## Draft Annual Code Amendments (MC20-01)

Note: The proposed amendments are shown as red text that is either underlined or crossed out.

Figure 18.17.060-1 Exterior Facing Retaining Wall

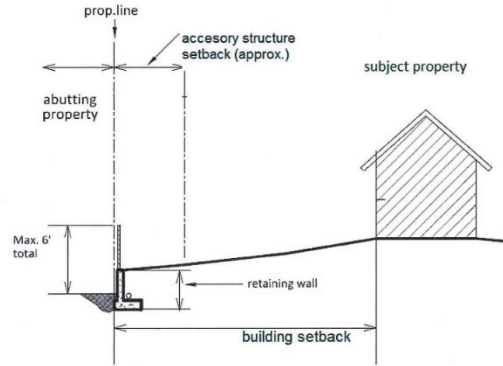
~~D.C.~~ [Exterior Facing Retaining Walls.] Exterior facing retaining walls are those walls that are supporting fill. The exposed side is facing the neighboring property or right-of-way and the fill side is within the subject property. (Refer to Figure 18.17.060-1 Exterior Facing Retaining Walls.)

1. When fence is atop the retaining wall, then the total height of wall and fence shall not exceed forty-two inches (front yard) or six feet zero inches (side and rear yards), or set back a distance of one foot for every foot in height of fence in excess of allowed height.
2. When retaining wall is over thirty inches above grade, then guards are required if on the property line.
3. If approved, retaining walls over six feet zero inches in height shall include landscaping to minimize bulky appearance, as approved by the Director. ~~will be subject to design review approval.~~

Figure 18.17.060-2 Interior Facing Retaining Wall

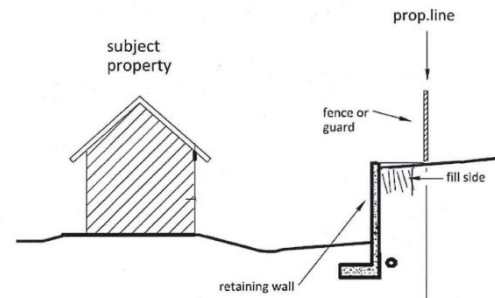
~~E.D.~~ [Interior Facing Retaining Walls.] Interior facing retaining walls are those walls that are supporting cuts. The fill side of the retaining wall is facing the neighboring property and the exposed side is facing the subject property. (Refer to Figure 18.17.060-2 Interior Facing Retaining Walls.)

1. When fence is atop the retaining wall, then the total height of fence shall not exceed forty-two inches (front) or six feet zero inches (side and rear) depending on location, unless fence meets setbacks.
2. When retaining wall is over thirty inches above grade, then guards are required if on the property line.
